Access Compliance Report

Public Rights-of-Way

Intersection ID: 27431	Main Street: BALLANTYNE COMMONS PY	Cross Street: RUSHMORE DR	Location:	SW
ADA ID: 65EFFA0D627A	Ramp Type: Perpendicular	Initial Pass/Fail: Fail	Overall Compliance: No	Severity Score: 10
Codes/Mitigation Info/Possible Solution		Field Measurements/Component Compliance

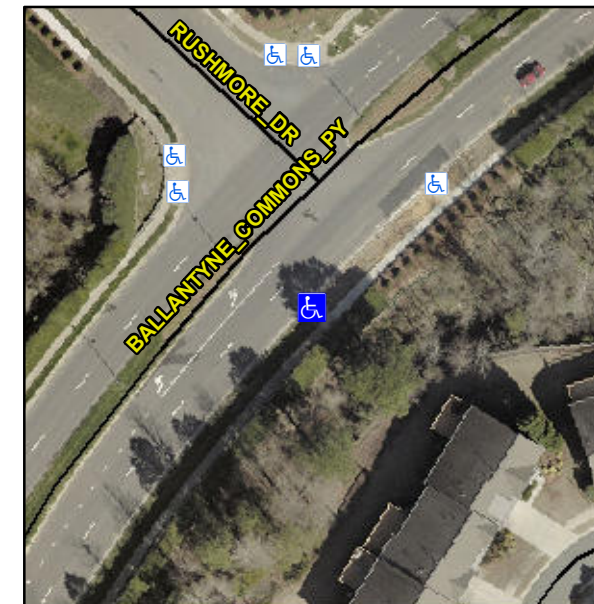
Not Found, R304.5.1, R304.5.3

Compliance	Description	Data	Compliance	Description	Data
N/A	Ramp Length (in)	119.0	Yes	Ramp Slope (%)	5.4
No	Ramp Width (in)	47.0	No	Ramp XSlope (%)	3.8
N/A	Flare Type LT	N/A	N/A	Flare Type RT	N/A
N/A	Flare Slope LT (%)	N/A	N/A	Flare Slope RT (%)	N/A
N/A	Flare Traversable LT?	N/A	N/A	Flare Traversable RT?	N/A
N/A	Landing Length (in)	N/A	N/A	DWS Provided?	N/A
N/A	Landing Width (in)	N/A	N/A	DWS Contrast?	N/A
N/A	Landing Slope (%)	N/A	N/A	DWS Length (in)	N/A
N/A	Landing X Slope (%)	N/A	N/A	DWS Full Width?	N/A
N/A	Landing Curb? (Y/N)	N/A	N/A	DWS Offset (in)	N/A
N/A	Shared Landing?	N/A			
N/A	Gutter Ponding?	N/A	N/A	Gutter Slope (%)	N/A
N/A	Gutter Lip Ht (in)	N/A	N/A	Gutter X Slope (%)	N/A
N/A	Painted X Walk1?	No	N/A	Painted X Walk2?	N/A
	X Walk 1 Direction	To NW		X Walk 2 Direction	N/A
N/A	X Walk 1 Width (in)	N/A	N/A	X Walk 2 Width (in)	N/A
	X Walk 1 Slope (%)	3.5		X Walk 2 Slope (%)	N/A
	X Walk 1 X Slope (%)	0.9		X Walk 2 X Slope (%)	N/A

Remove & Replace Entire Ramp.
